Further Objection to Planning Application 2024/0012/P – 194 Goldhurst Terrace following uploading of new documentation in October 2024

This further objection should be read in conjunction with my original objection letter, submitted in February. For ease of reference, the full original objection letter is included as **Annex 1** to this document.

Figure 6.1: Groundwater flows around basements – pre and post-development

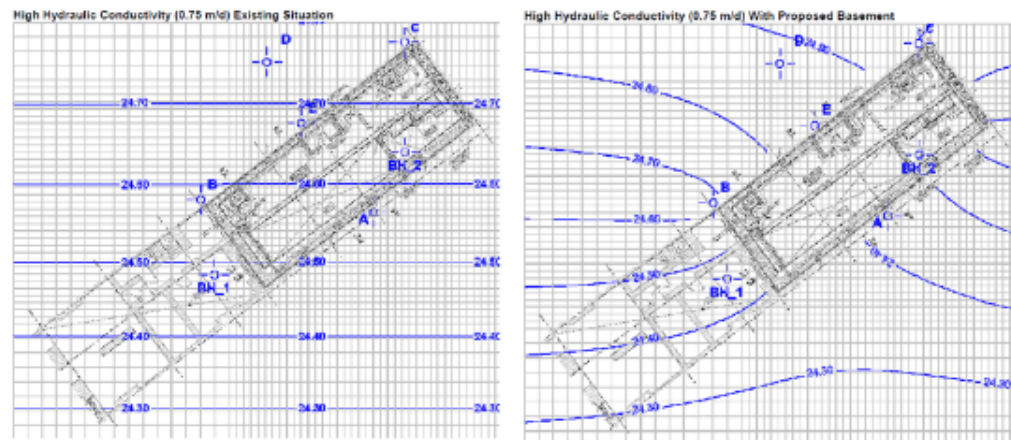
The Camden SFRA is an important document and includes full coverage of the interplay between flood risk and groundwater levels and applications for basement excavations and I would request the BIA Engineer and Camden's BIA Auditors, and the Case Officer to please carefully read paras. 6.4.3 to 6.4.9. This includes a very helpful illustration of how existing groundwater flows can be significantly changed by a basement excavation (see Figure 6.1 and its description in para. 6.4.6).

For ease of reference, **Annex 3** of this objection includes an extract of paras. 6.4.3 to 6.4.9, including Fig. 6.1 which gives a very helpful illustration of the effects that building a large, impermeable basement structure can have on groundwater flows. (Note: The large scale of the proposed basement excavation on the subject site is wholly unprecedented for this area).

The Camden SFRA document also goes on to say (para. 6.4.6) that: *"As part of the assessment carried out for basement development it will be important to identify any potential receptors which may be affected by the change in water level. Locally within the LBC area, the main receptors are likely to be existing basements, various abstraction sources from the River Terrace Deposits and groundwater-fed water features. A basement search radius of 500m around a development is advisable to inform a basement impact assessment."*

It appears that the recommendation of a basement search radius of as much as 500m is persistently (and probably deliberately?) being ignored. A very few BIAs list just a few other excavations within less than 100m of the subject site, while most (regrettably including this one) do not even do that. It is likely that there will be at least 15 to 30 new basements that have been excavated in the last 30 years within a

Camden must in this case (194 Goldhurst Terrace), and routinely for future cases, insist on a much more exhaustive list of recent basements built within 500m of the site, and before considering whether to give consent for such a large-scale and voluminous further excavation (almost certainly larger than any other single basement excavation done in the whole South Hampstead Conservation Area over the last 20-30 years).
